<h1>SERVICE BULLETIN</h1>		Aircraft type:	ALTO 912 TG ALTO NG
	No. SB-0-002-2024-EN	MANDATORY	Revision:	00

<u>Applicability:</u>	S/N: DF125, DF160, DF176, DF200, DF202, DF213
<u>Concurrent ASB/SB/SI and SL:</u>	None
<u>Reason:</u>	Yaw control path fuselage structure collision (in the case of pedals with shifted position installation)
<u>Subject:</u>	Perform manual repair according to instructions
<u>Compliance:</u>	Immediately, before next flight
<u>Approval:</u>	Inform manufacturer
<u>Labour time:</u>	0.5 hr
<u>Mass data:</u>	Change of weight: none Change of CG: none
<u>Electrical load data:</u>	None
<u>Software modifications:</u>	None
<u>References:</u>	None
<u>Other Publications affected:</u>	None
<u>Interchangeability of part:</u>	None

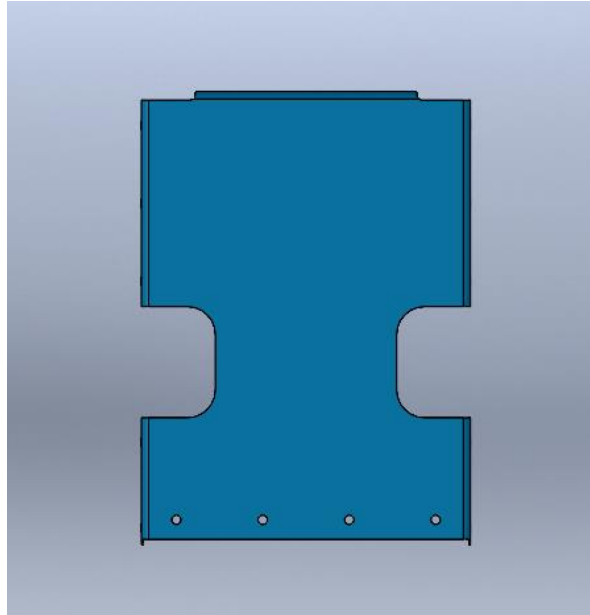
- 1) Collision takes place below and behind the instrument panel.

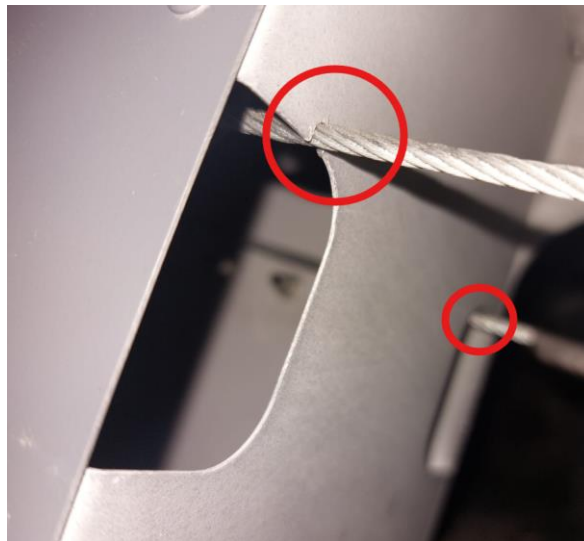
- 2) Frame which is affected is numbered as 2_02_11_09:

- 3) In the case of shifted pedals installation (in direction to the firewall) there is a collision between the control cables and the fuselage structure.

- 4) In such a place there is a need for the cutaway to be expanded. Also check for the condition of control cables (look for any wear and fraying). Pay attention when performing the cutaway. Make sure that your tooling will not interfere with control cables. The cutaway must be performed on both sides (left and right cable).
- 5) Enhanced hole must allow for the free movement of the cables without any further collision. Gap of 5mm between the cable and sheet metal can be considered as satisfactory.
- 6) Sharp edges must be sanded. Example of the hole enlargement:
